#### THIRD READINGS SUMMARY SHEET

<u>CASE</u>: C814-2023-0057 (200 E. Riverside PUD) <u>DISTRICT</u>: 9

#### **ZONING CHANGE REVIEW SHEET**

<u>CASE</u>: C814-2023-0057 (200 E. Riverside PUD) <u>DISTRICT AREA</u>: 9

**EXHIBIT R** City of Austin Council Meeting Backup: May 22, 2025

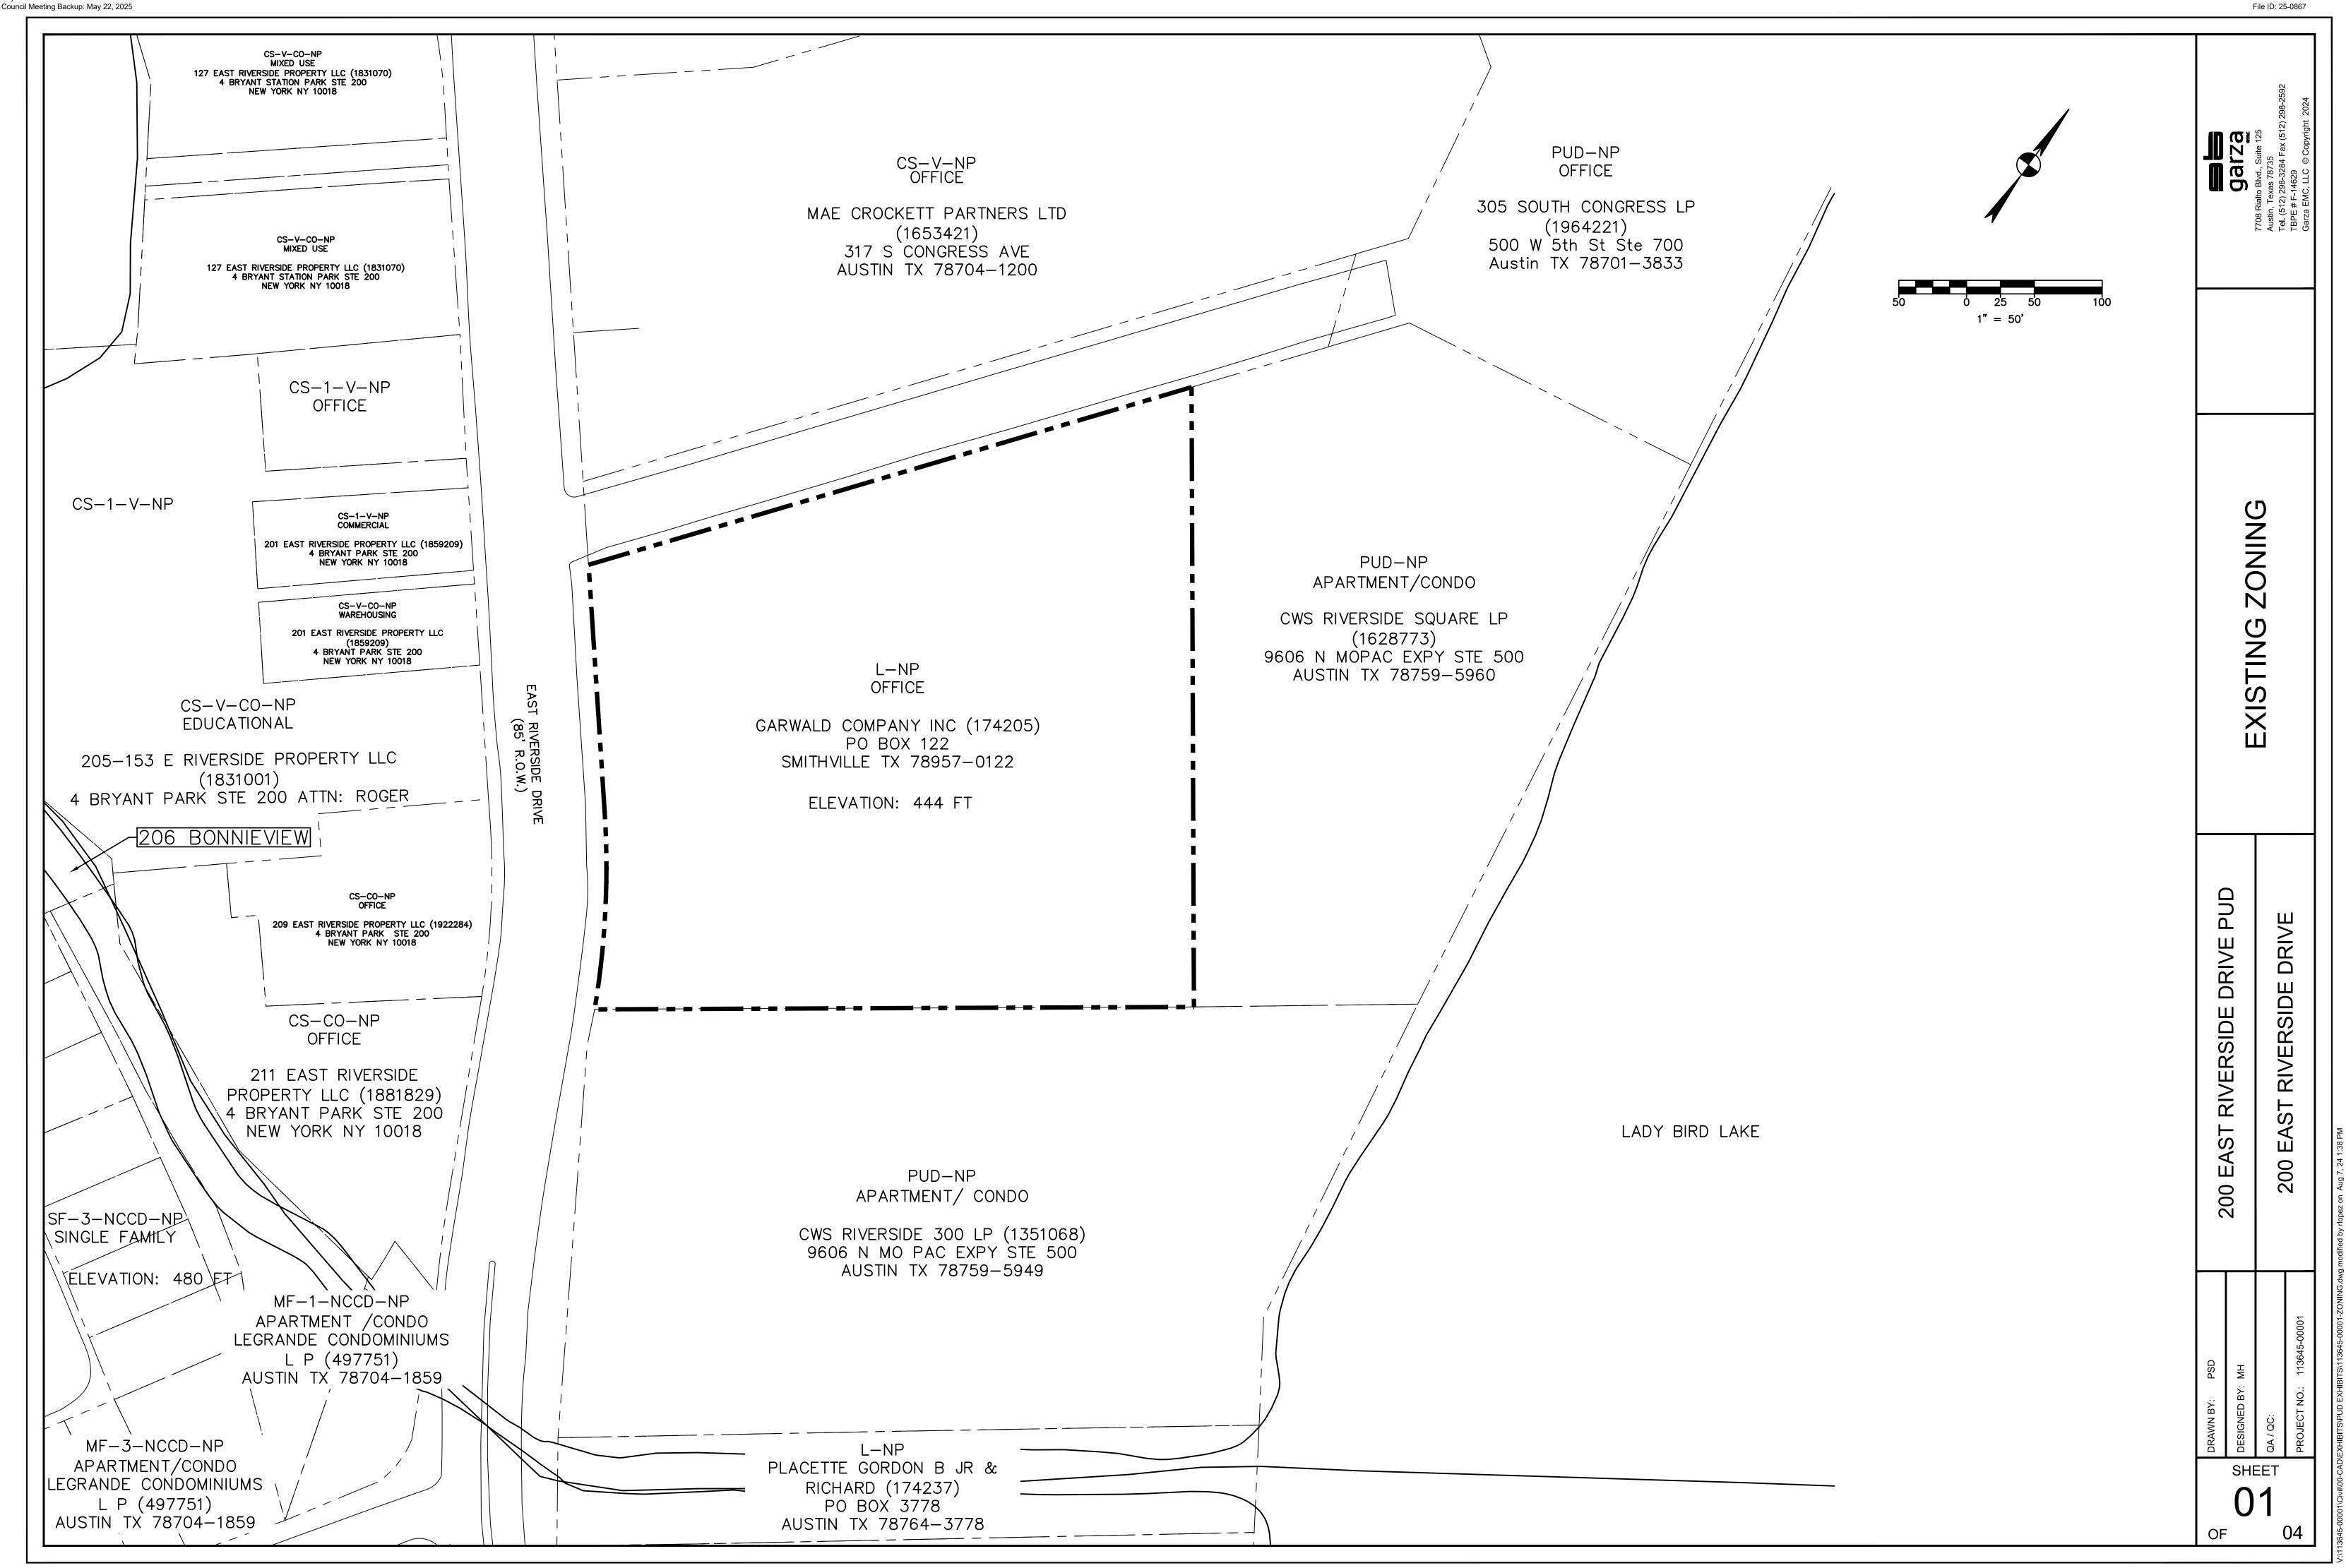
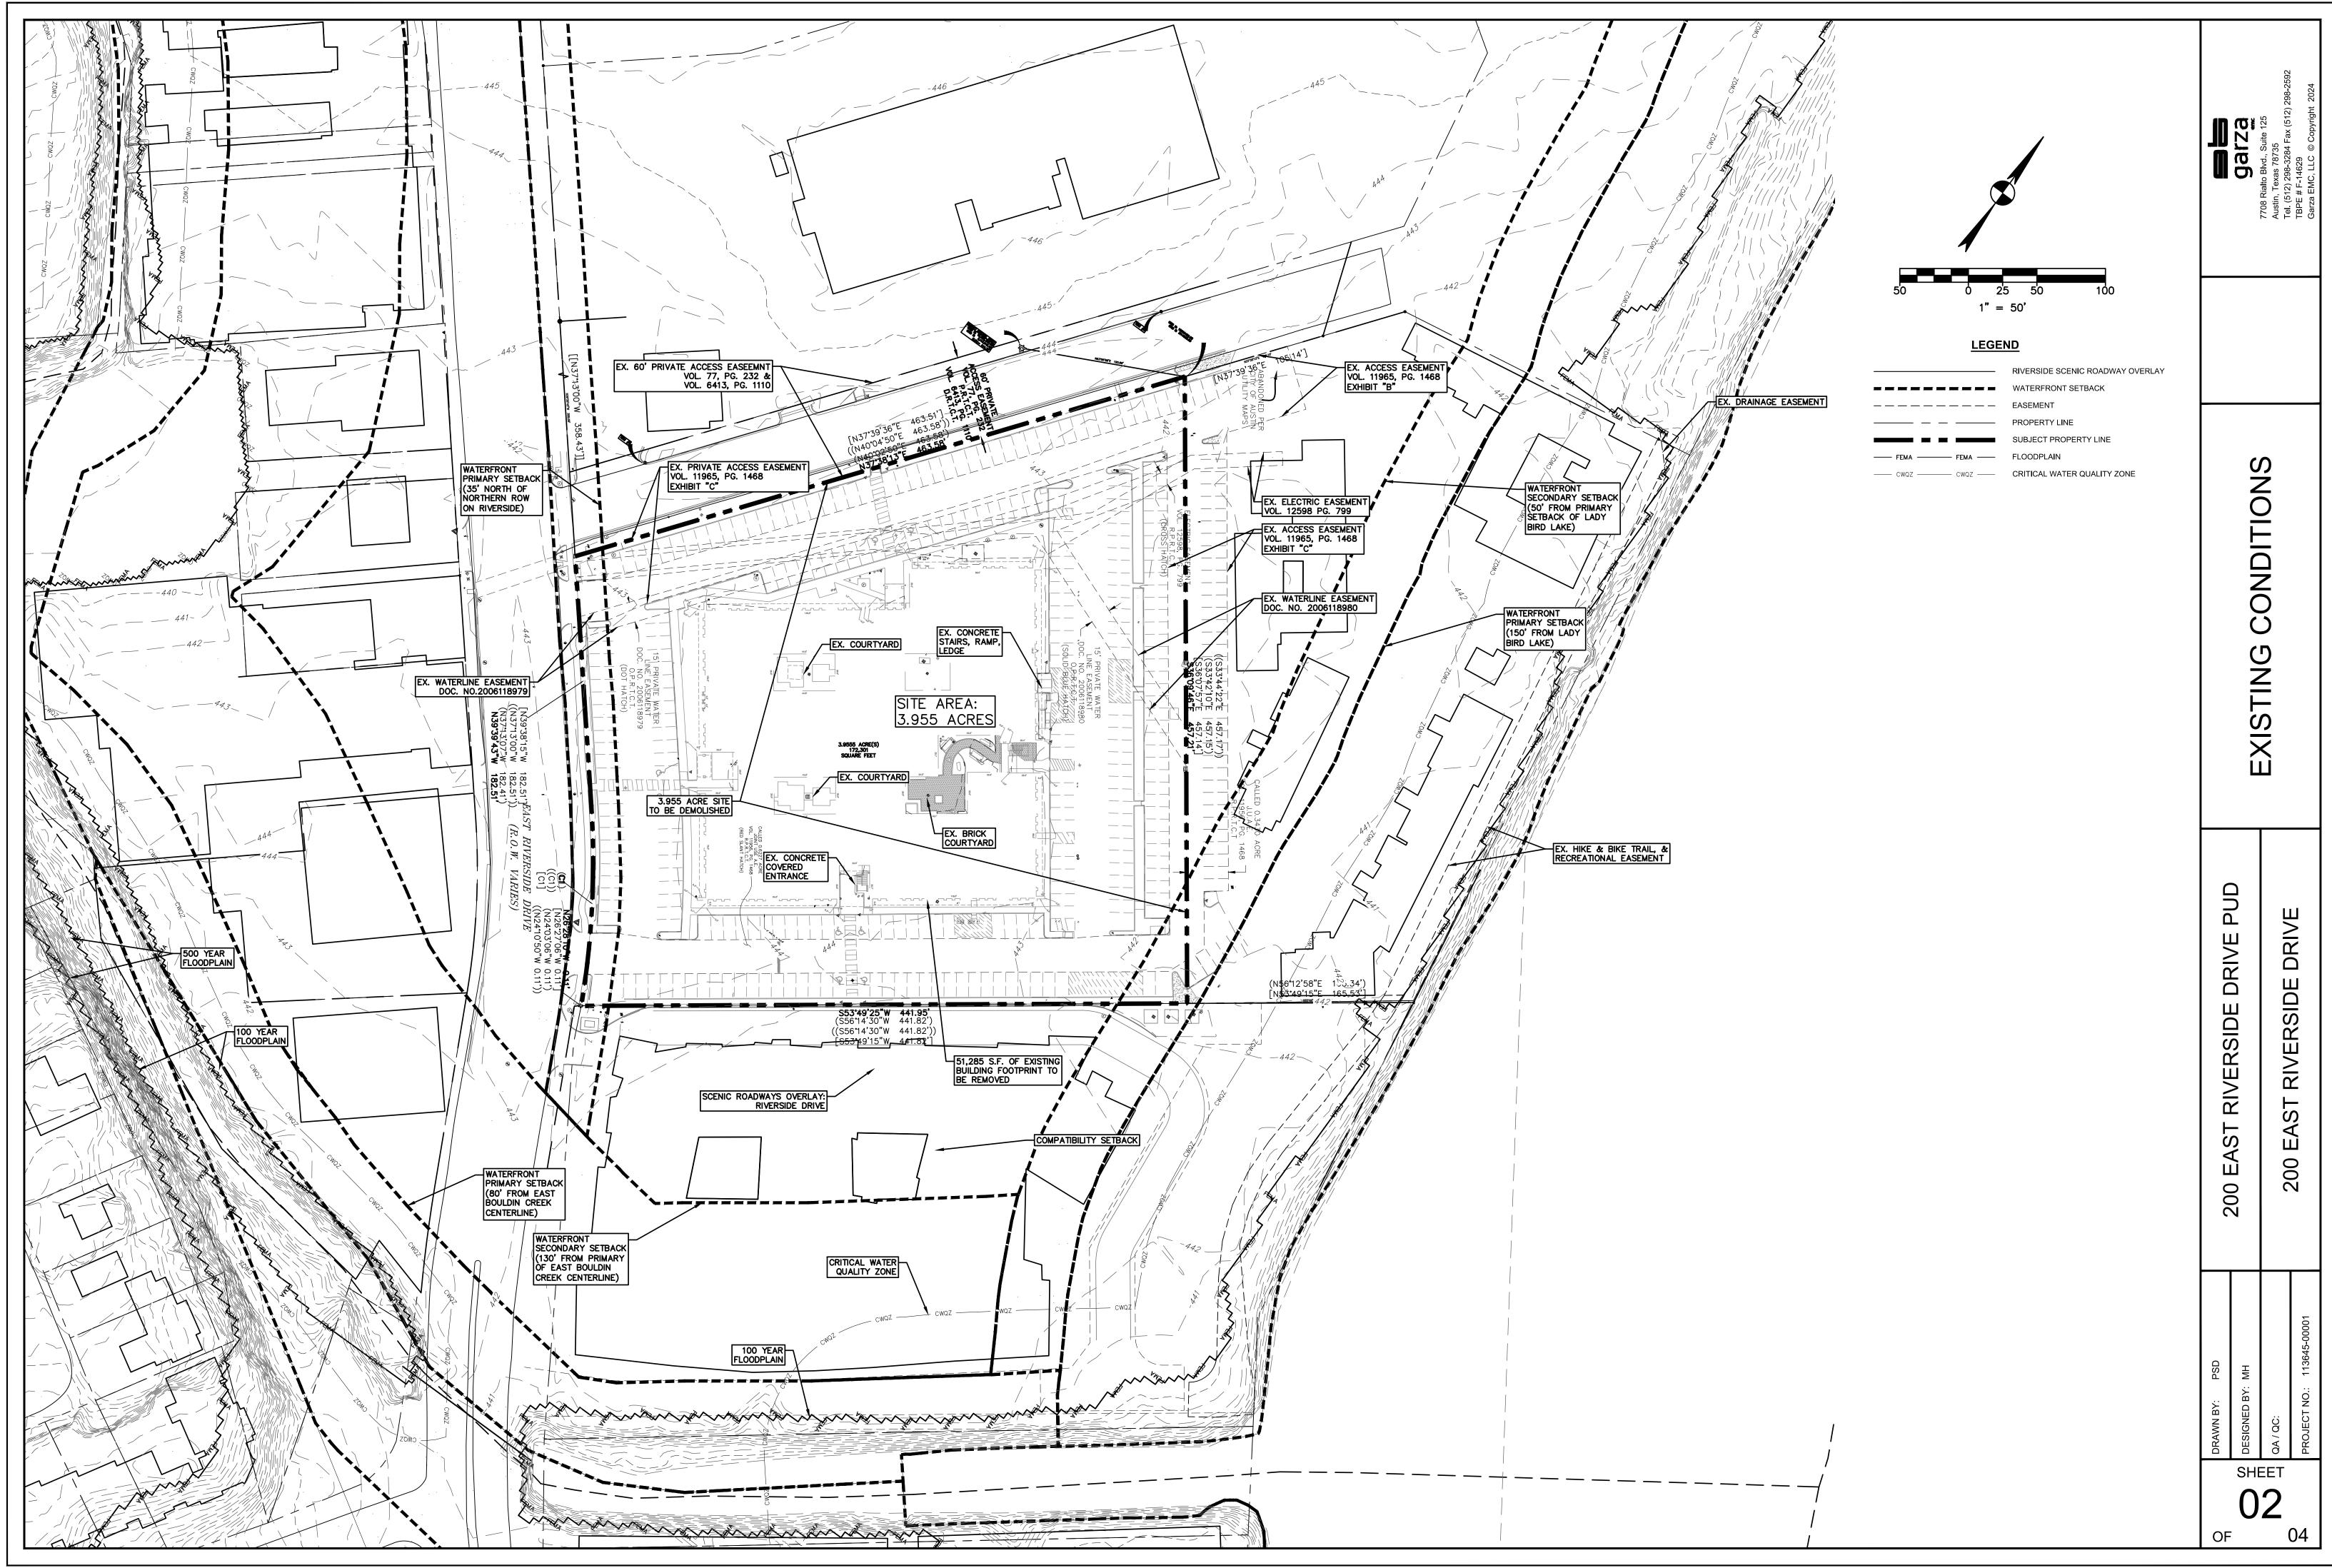
After meeting with the staff and City Council offices, on April 8, 2025, the applicant submitted a letter amending their application to modify the following conditions for the proposed PUD zoning (please see Applicant's Amendment Letter - Exhibit Q and Amended Exhibits - Exhibit R):

- 1. Increase the proposed maximum floor-to-area ratio ("FAR") to 25: 1.
- 2. Increase the maximum height allowed in Area 1 to 600 feet for buildings located within approximately 232 feet of the western property line as shown on the Land Use Plan.
